**Appendix J**  
**Correspondence with the Ministry of the Environment**

**Re: Recognition of Approved Site Capacity  
Ruby Road Waste Disposal Site, Township of Bonnechere Valley, Renfrew County  
Cambium Ref. No. 07-1219-001**

Cambium Environmental Inc. (Cambium), on behalf of the Township of Bonnechere Valley (Township), has prepared the following response to your review of the *Numerical Hydrogeological Modelling Report for Expansion Feasibility of the Ruby Road Waste Disposal Site* (Cambium 2009) provided in correspondence dated June 29, 2009.

**Re: Response to Review Comments and Finalization of Groundwater Modelling Report  
Ruby Road Waste Disposal Site (A411501)  
Cambium Reference No. 1219-001**

**Figure A:** Existing Road Waste Disposal Area (indicated by pushpin). Excerpt of Ontario Geological Survey Map 2459 and the rotated Numerical Model domain are overlaid. Bedrock Unit 10e (light blue) = marble. Unit 5a (dark grey) = arkose.

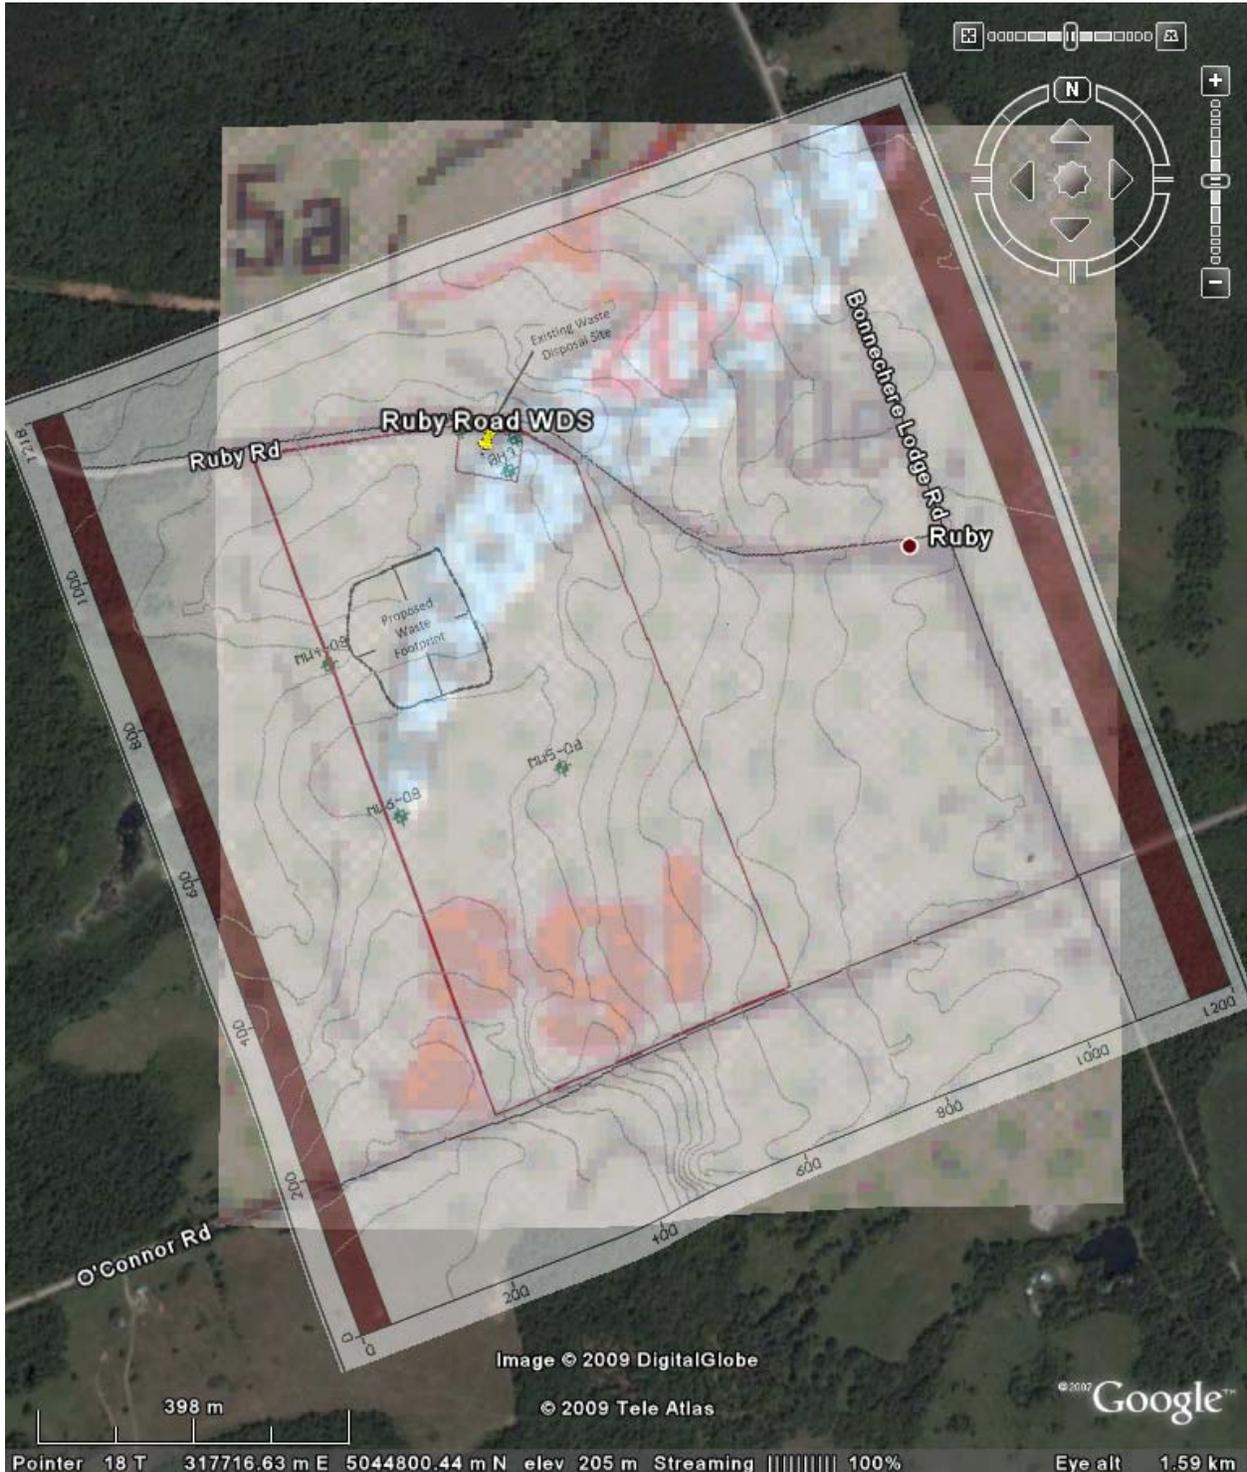
Borehole information is available for three locations at the existing former waste disposal site. Additionally, three newer boreholes were constructed during May 2008 around the proposed new fill area. Figure A at the end of this memo depicts the location of these boreholes.

Precambrian metamorphic rock underlies the overburden. Ontario Geological Survey Map 2459 (Pembroke) depicts at least two dissimilar types of bedrock beneath the site. Figure A, attached, includes the relevant section of this map. The companion OGS Map 2460 (Cobden) provides a detailed legend describing the bedrock underlying the site as follows:

The consultants applied an average hydraulic conductivity value of  $0.0000067 \text{ m}^3/\text{m}^2/\text{s}$  to the entire bedrock aquifer. However, I cannot discount the possibility that arkose, marble and the boundary zones between them have dissimilar hydrogeologic properties. I question whether any uniform hydraulic conductivity value appropriately emulates the existing site conditions.

Figure No: **1**

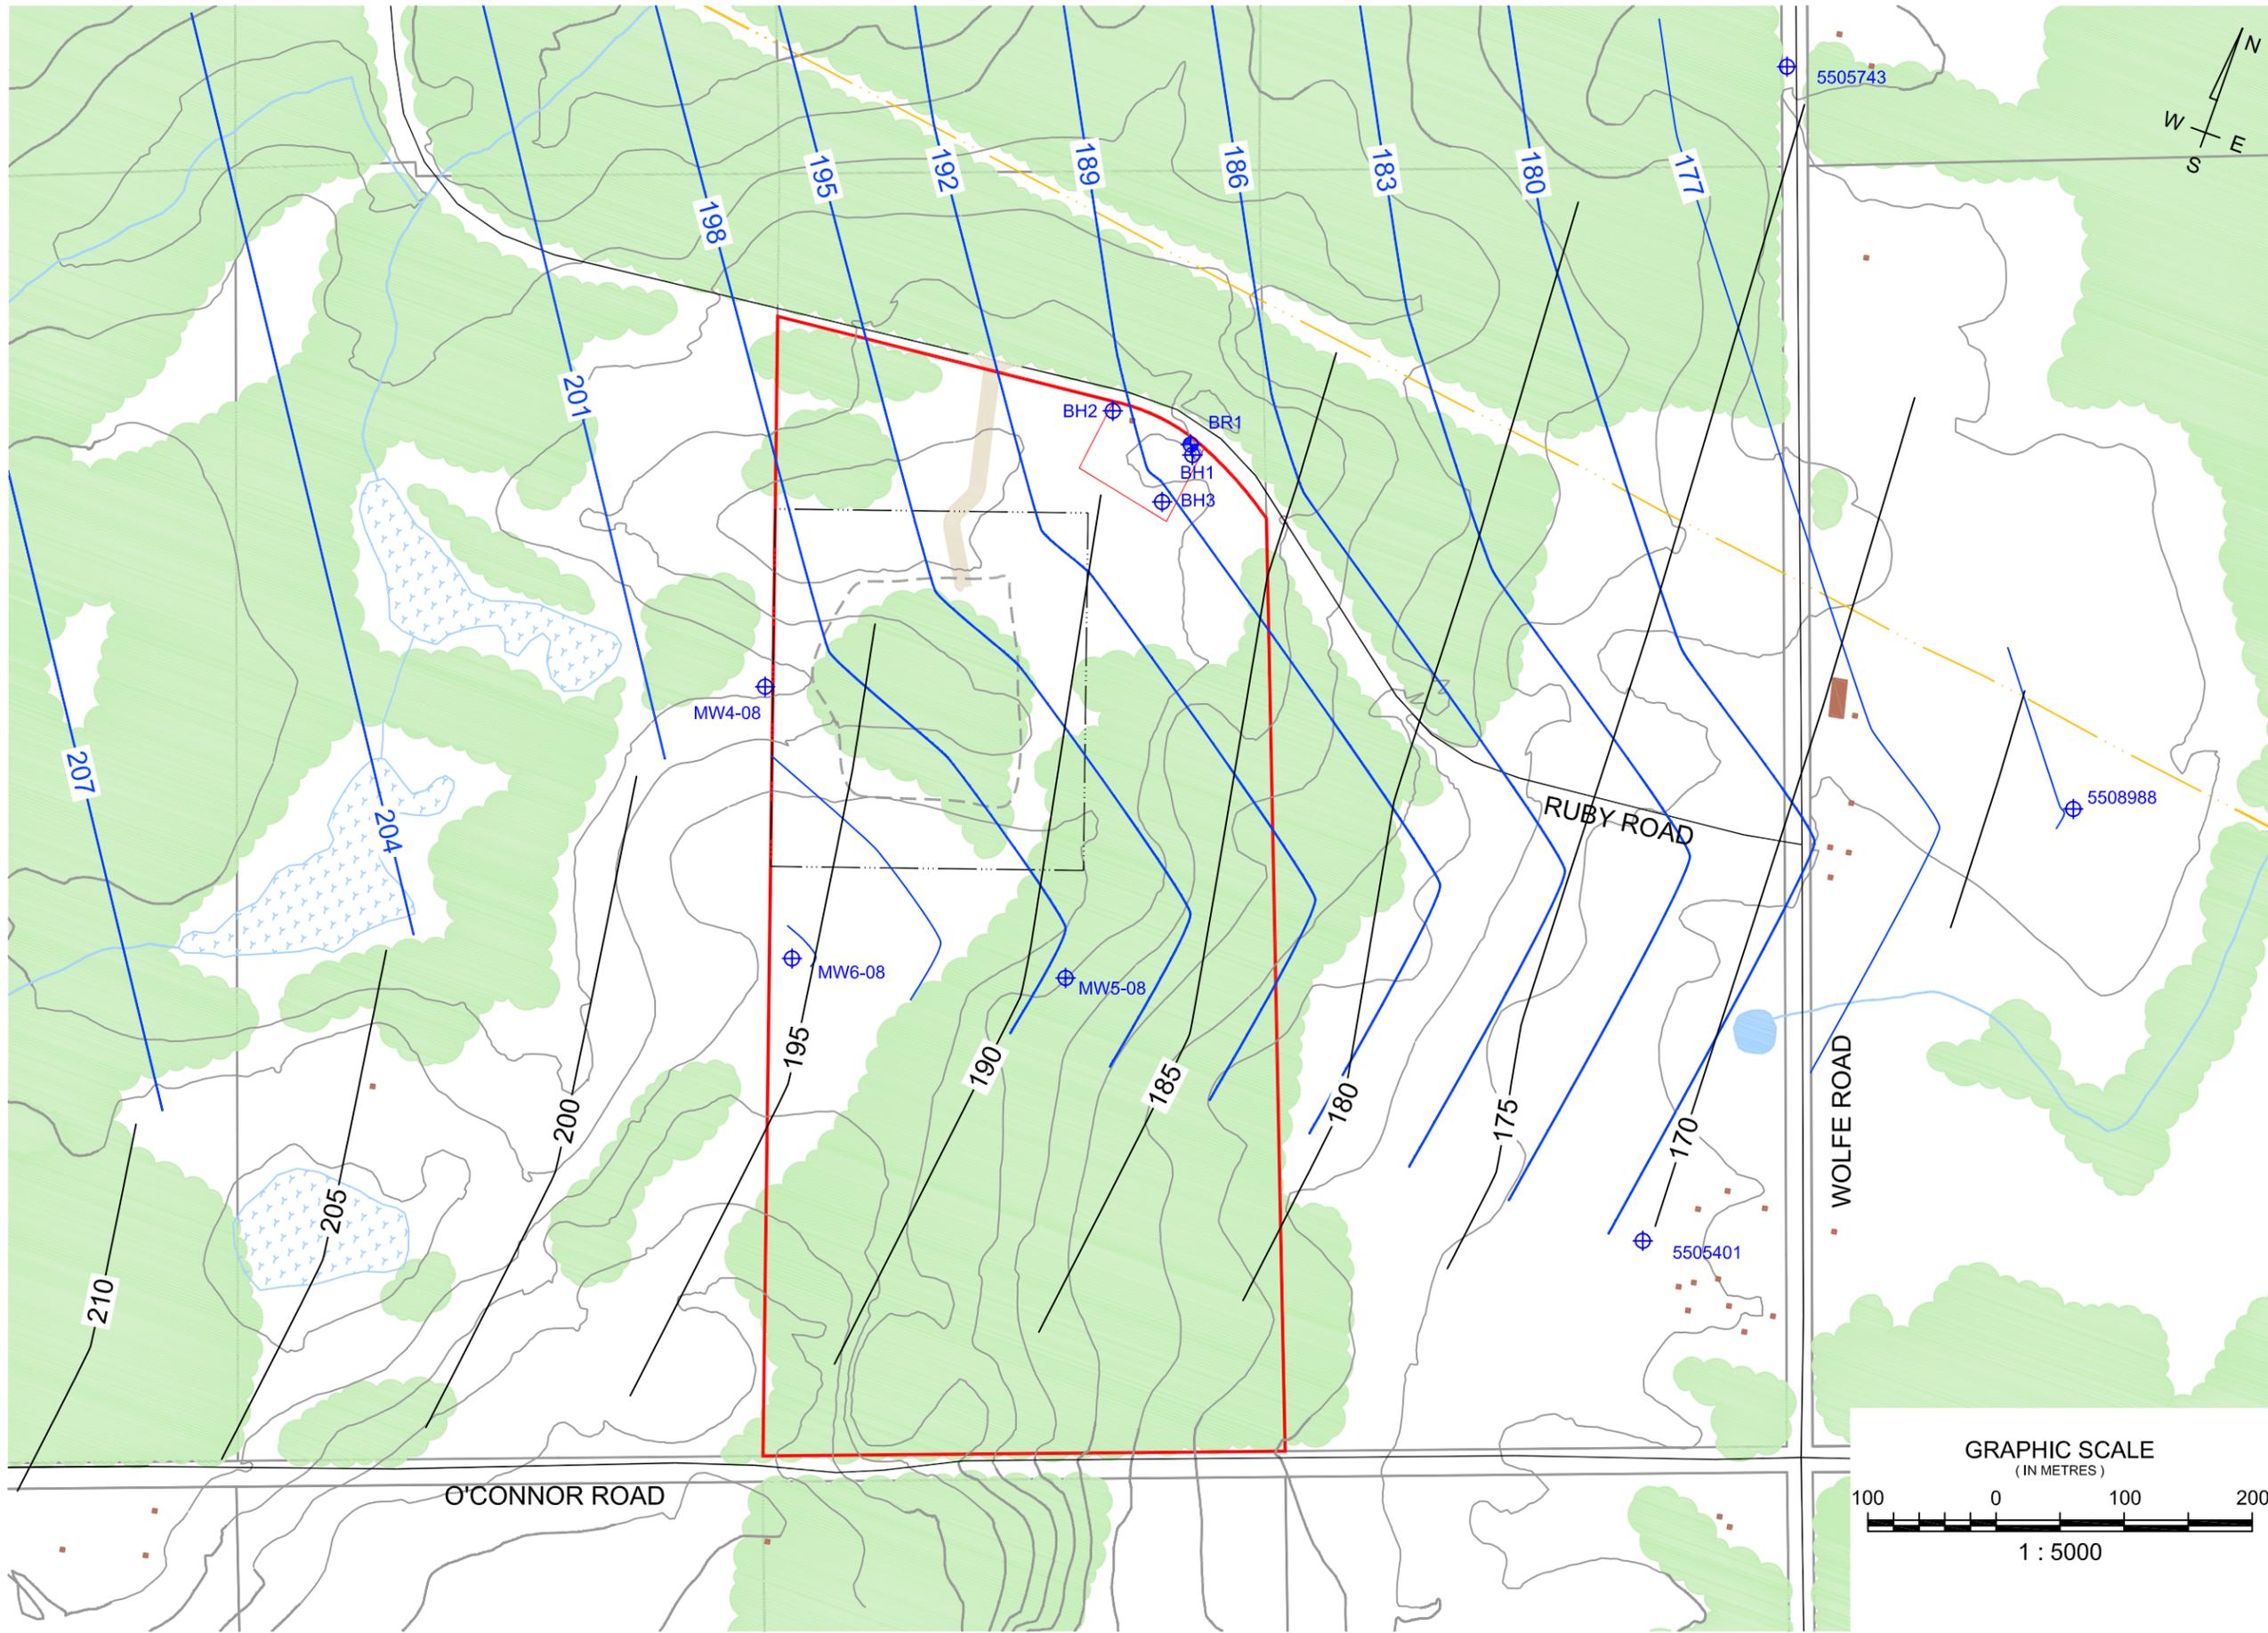
Cambium has also consulted the OGS Earth software and obtained information regarding bedrock geology from this mapping based in Google Earth. This mapping (refer to attached Figure 1) indicated the entire site, existing and expansion areas, are of unit 51 which is described as the following:

Drawn By: SNR	Checked By: JPD	Scale: HORZ: 1:3000 VERT: N/A
Date: August 2010	Revision Date:	Figure: <b>1</b>
Project No.: 1219-001

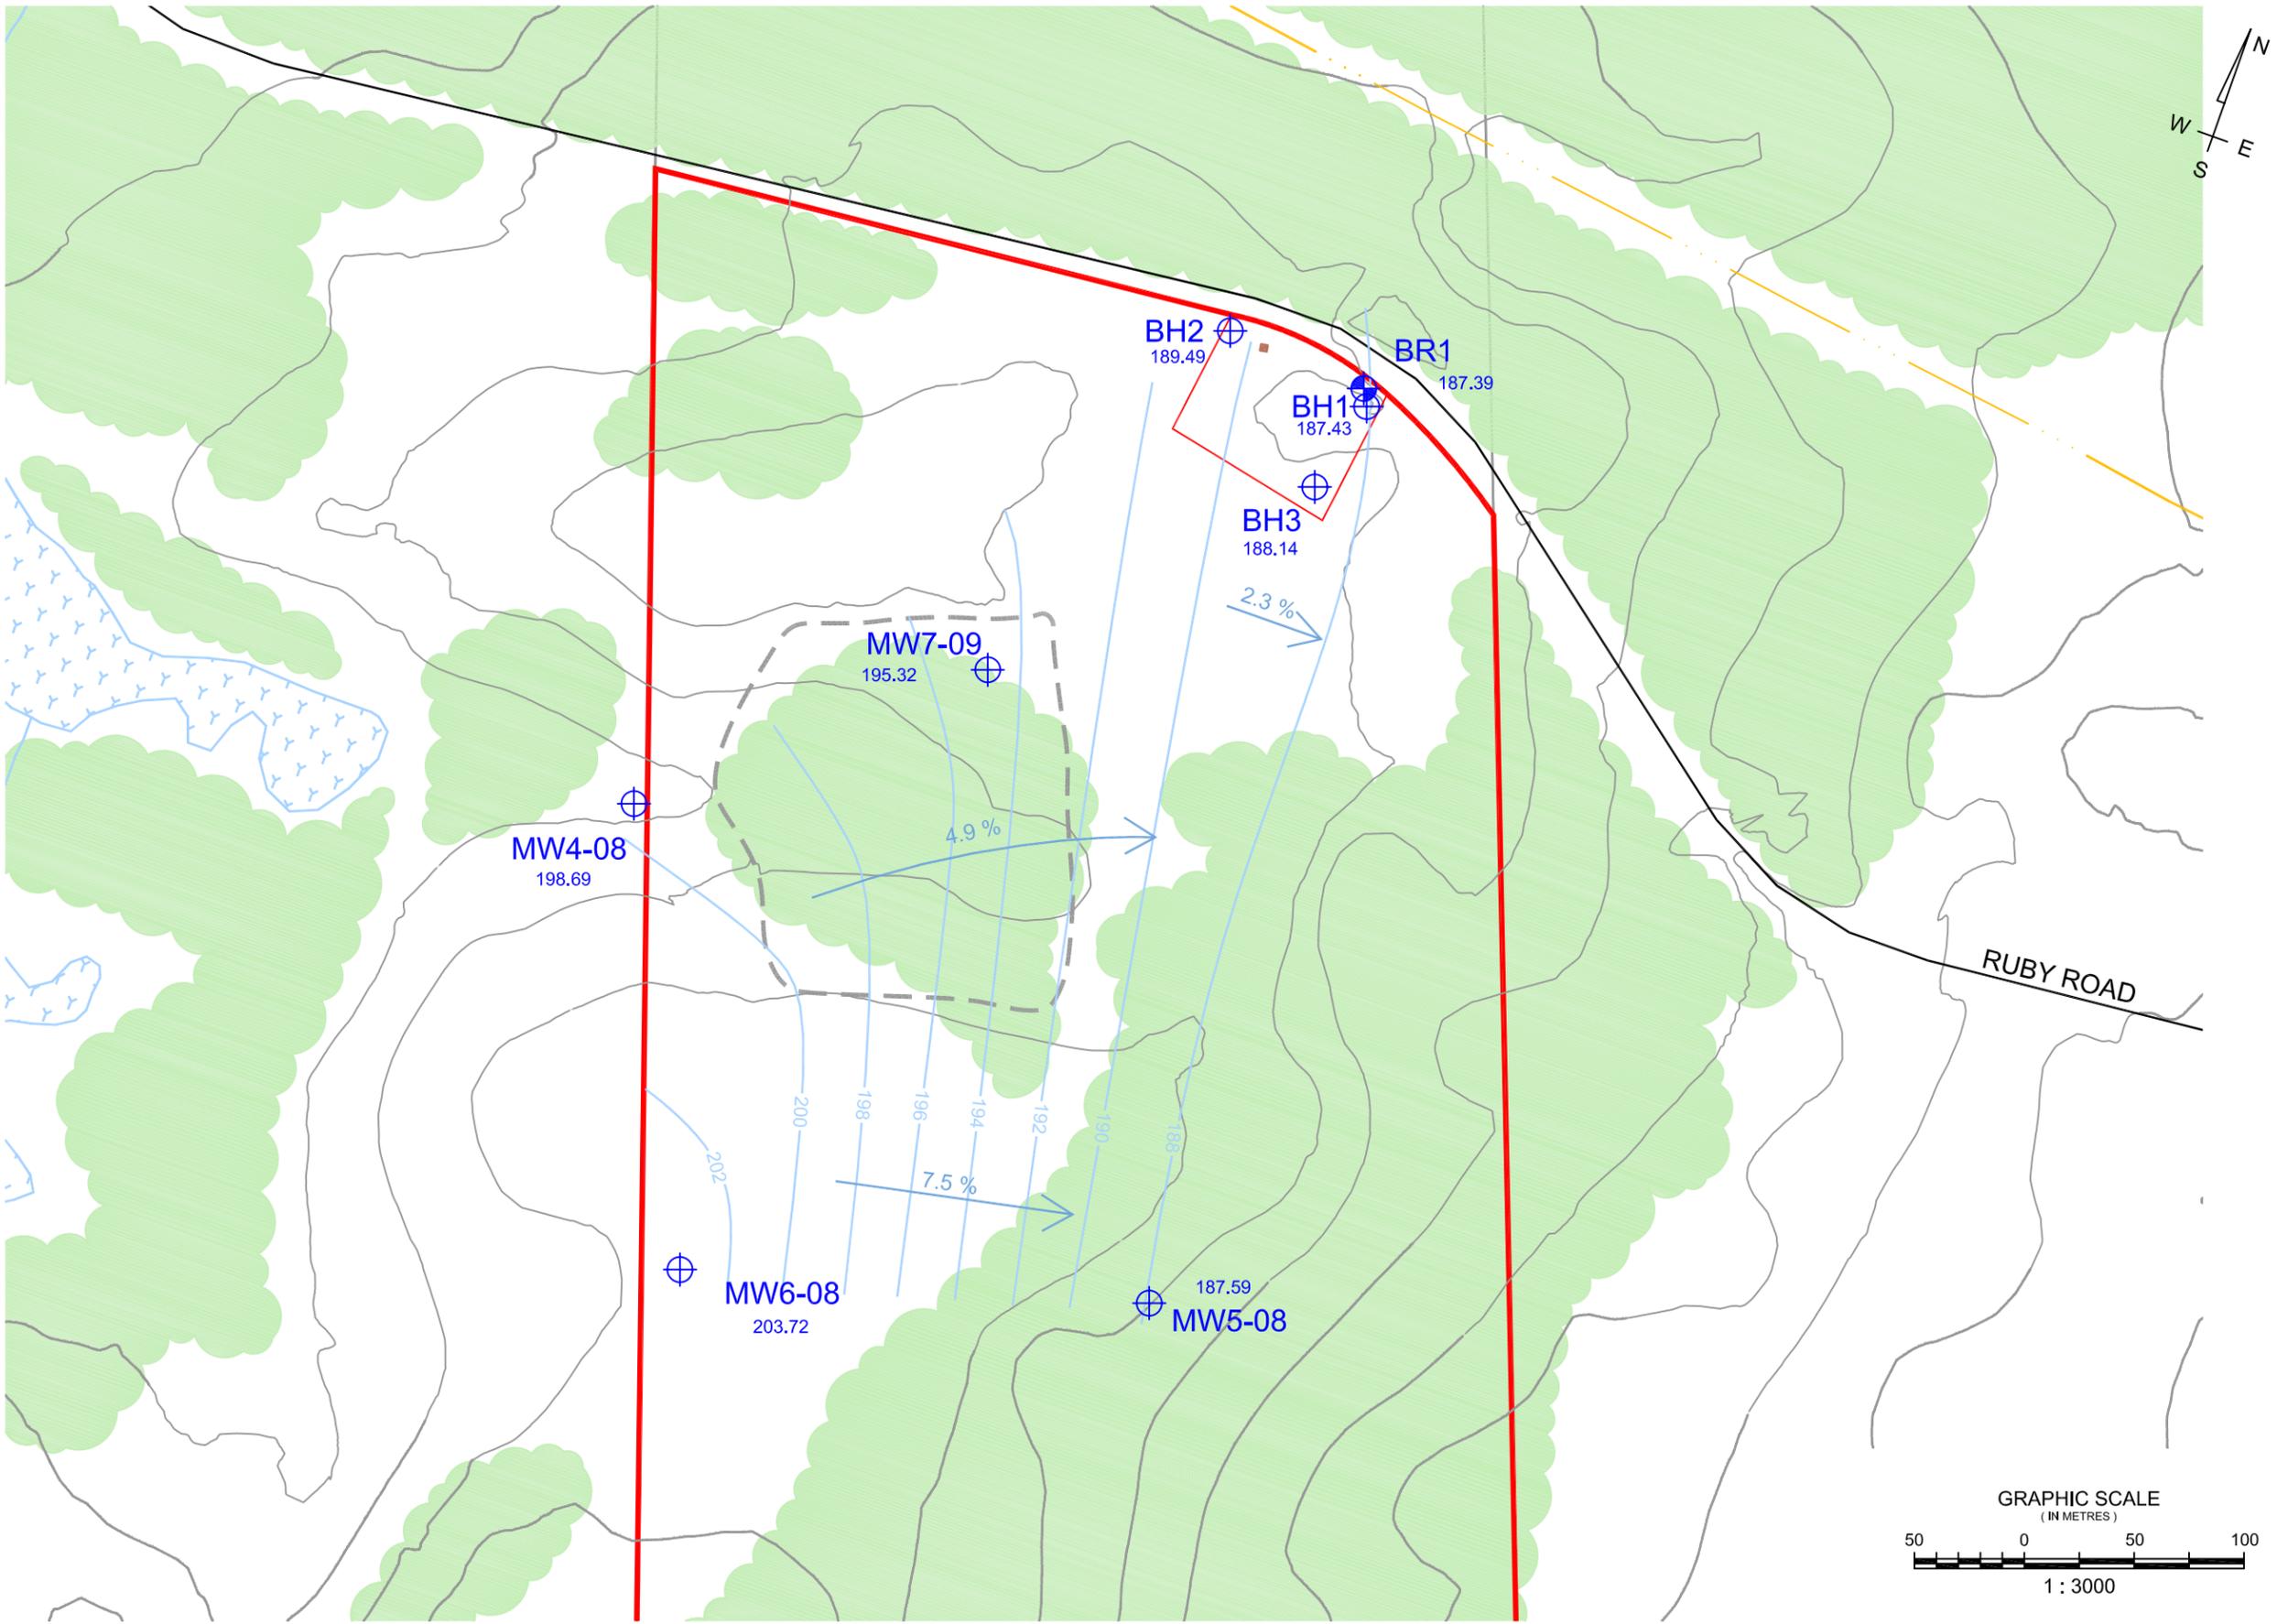
The complete groundwater pressure distribution model, as depicted in Figure 7, shows the hydraulic gradient of 0.07 metres per metre to exist between the wells south of the proposed waste area and not in the contaminant attenuation zone. A horizontal hydraulic gradient of approximately 0.05 metres per metre exists through the proposed footprint and reduces to a horizontal hydraulic gradient of approximately 0.03 metre per metre to the east of the proposed footprint in the contaminant attenuation zone. Refer to the attached Figure 1 Groundwater Configuration April 2010, as completed in AutoCAD.
